RHODE ISLAND DEPARTMENT OF TRANSPORTATION

RHODE ISLAND CONTRACT NO.2014-CB-037

Great Island Br. #499

ADDENDUM NO. 4 Prospective bidders and all concerned are hereby notified of the following changes in the Plans, Specifications, Proposal and Distribution of Quantities for this contract. These changes shall be incorporated in the Plans, Specifications, Proposal and Distribution of Quantities, and shall become an integral part of the Contract Documents.

SKETCH NO.
2

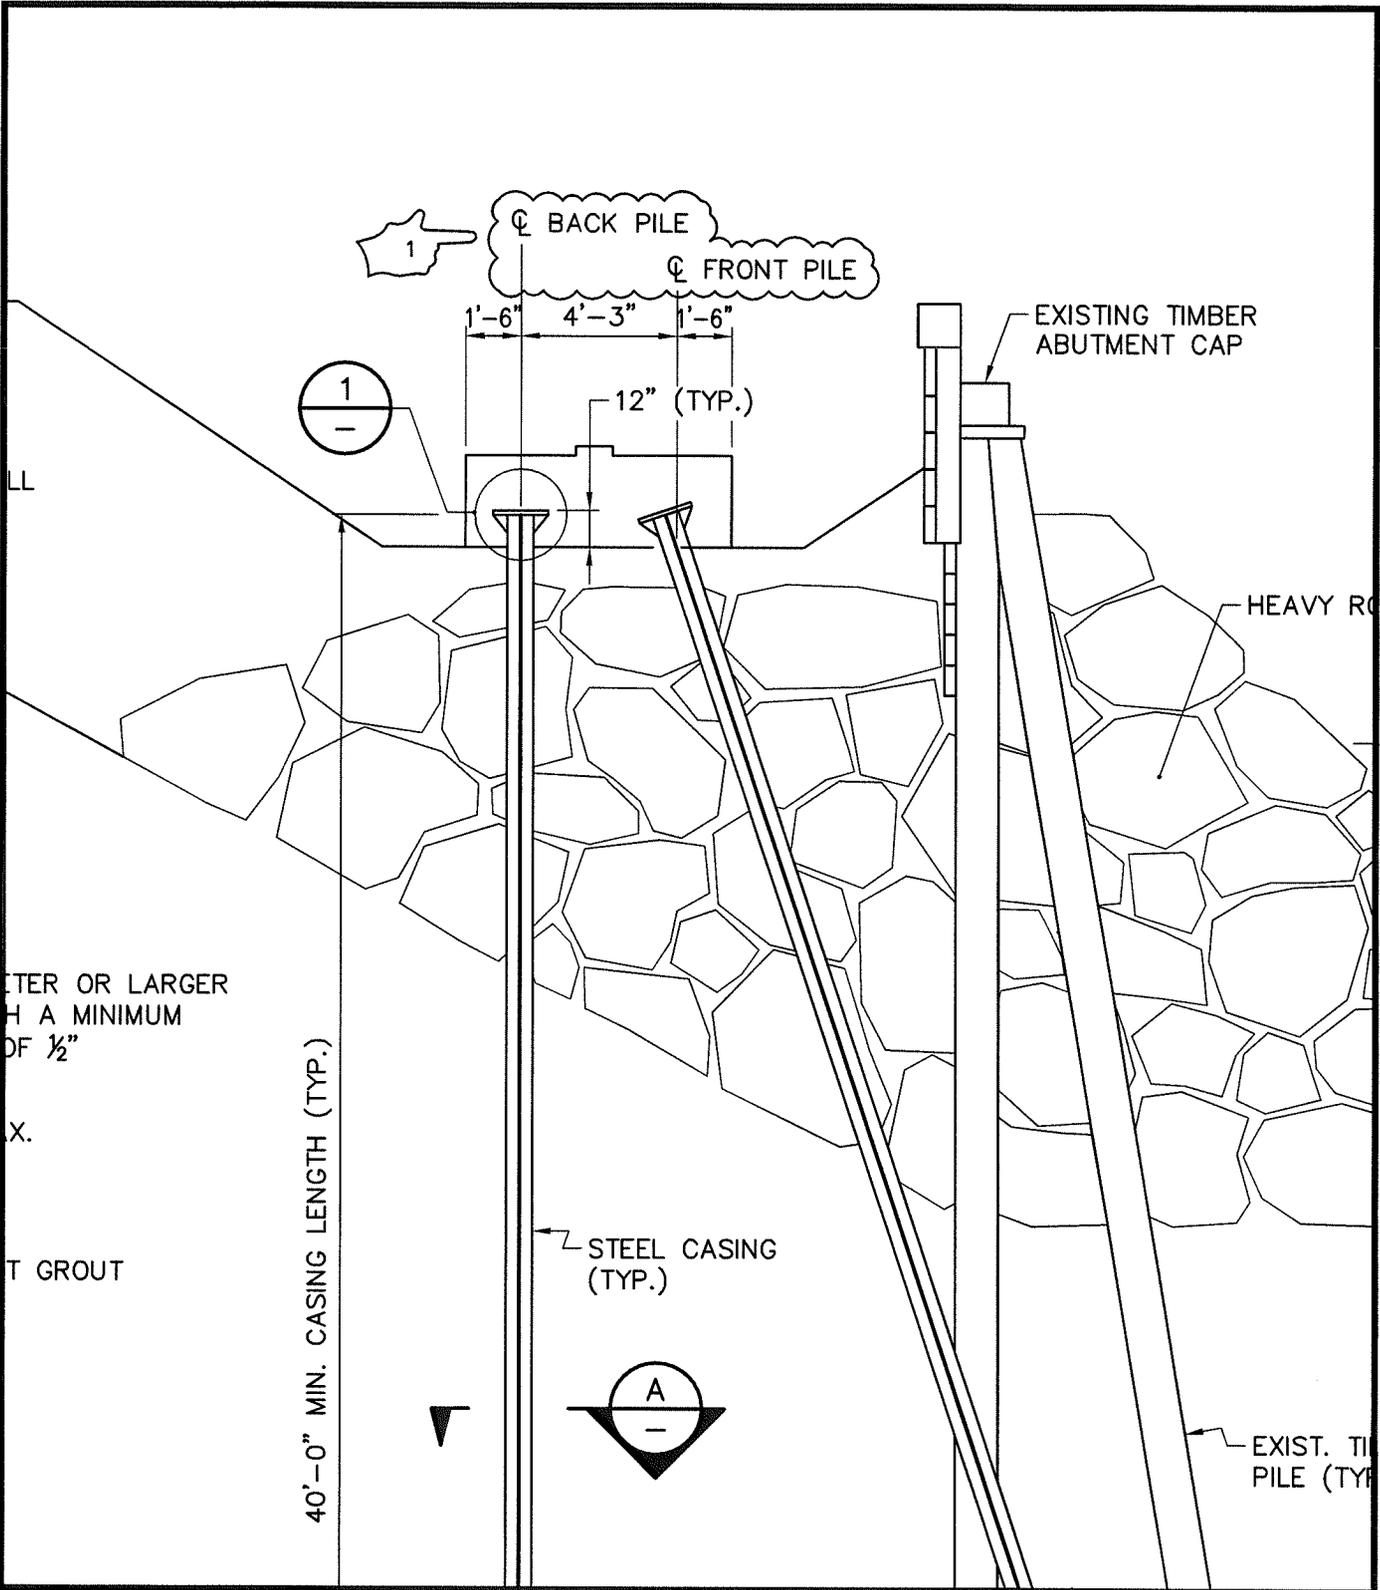
2. Sheet No. 10 – Micropile Pile Details
Revise Sheet No. 10 as shown on Sketch No. 2(R-1) and Sketch No. 3(R-1) attached to this Addendum No. 4. Centerlines of Front and Back Piles have been noted in Typical Section at Abutment, and Micropile Structural Design Loads have been added.

MICROPILE STRUCTURAL DESIGN LOADS			
LIMIT STATE	AXIAL LOAD (KIP)		LATERAL LOAD (KIP)
	FRONT PILE	BACK PILE	
SERVICE	96.5	-3.9	5.6
STRENGTH (MAX. AXIAL)	128.6	9.9	3.6
STRENGTH (MAX. LATERAL)	85.2	-45.5	11.8
EXTREME	95.6	-85.5	7.6

1. THE CONTRACTOR'S MICROPILE STRUCTURAL DESIGN SHALL BE BASED UPON THE LOADS PROVIDED ABOVE; AXIAL LOAD RESISTANCE SHALL BE VERIFIED BY LOAD TESTING AS DESCRIBED IN THE ITEM CODE 804.99.
2. LOADS GIVEN ARE FACTORED LOADS PER PILE AT THE BOTTOM OF FOOTING ELEVATION.
3. NEGATIVE AXIAL LOAD INDICATES A TENSILE LOAD.
4. BOTH FRONT AND BACK PILES SHALL BE DESIGNED FOR THE GIVEN LATERAL LOAD.
